**Report: REVIVE REPORT
Function: Test, Adjust, & Balance
Date: 03/10/2023**

**02-20-23 FREDDY'S - MCDONOUGH, GA
(REVIVE)**

Issue Name : 05 - ACPSP is dirty

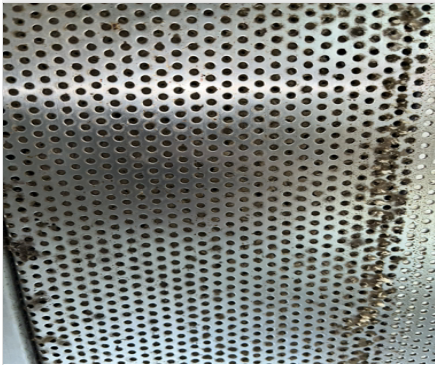
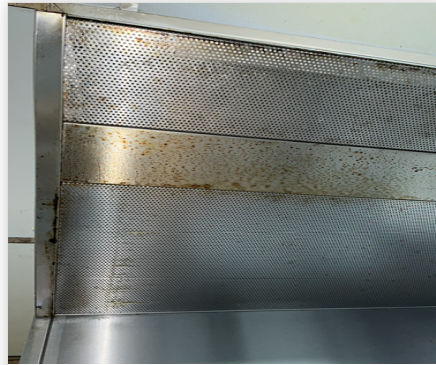
Description : Recommend dropping the AC-bsp portion and cleaning the top and bottom of the perforated grilles.
